Northaw Road, Cuffley Proposed Site Access - Option 2

Stage 1 Road Safety Audit

November 2014

ROAD SAFETY AUDIT REPORT & DESIGNERS RESPONSE

General Arrangement Plan

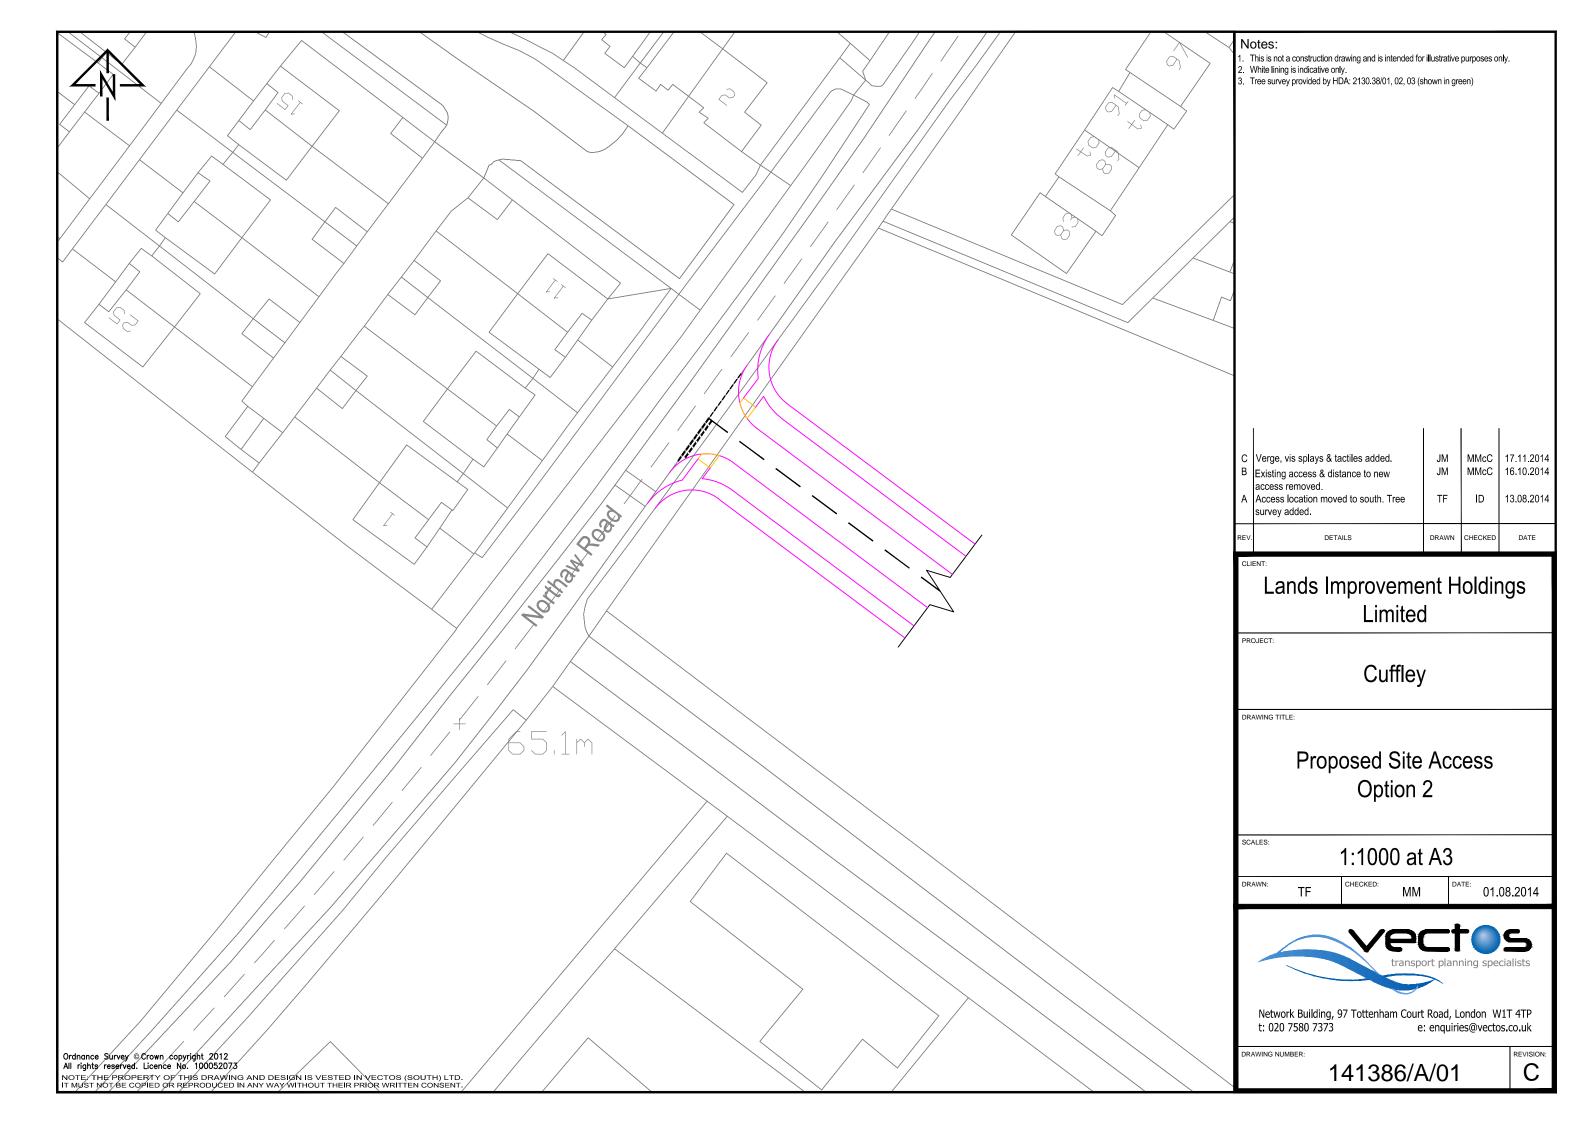
Summary: Swept path tracking has been provided for a refuse vehicle and fire tender. The swept path manoeuvre for the refuse vehicle is very tight and appears to cross over the footway on the western side of Northaw Road, resulting in potential conflict with pedestrians.

Ensure swept path manoeuvres can be accommodated within the carriageway.

3.4	Location: General Summary: Swept path tracking has been provided for a refuse vehicle and fire tender. The swept path manoeuvre for the refuse vehicle is very tight and appears to cross over the footways on the western side of Northaw Road, resulting in potential conflict with pedestrians.	Ensure swept path manoeuvres can be accommodated within the carriageway.	Noted. The swept path analysis of the refuse truck has been checked and this confirms that the manoeuvres can be undertaken within the carriageway. The updated drawing is included at Appendix A .
